MODBAR TECHNICAL BULLETIN
20
AV Tap Handle

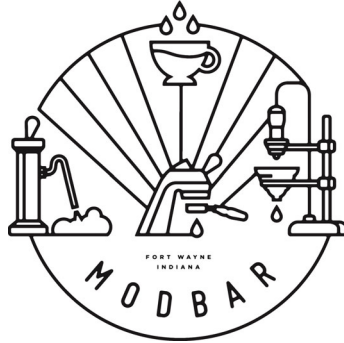
All Mobar AV taps will now have stainless steel handles as standard, starting with Serial #MB001004.

These handles conduct less heat from the group, so promote better temperature stability and feel cooler to the touch.

The new stainless steel handles have new part numbers:

- C.1.442.WW Handle MODBAR AV walnut
- C.1.442.MW Handle MODBAR AV maple

They are fully interchangeable with the previous handles, and they will soon be available as spare parts from Nuova Ricambi.
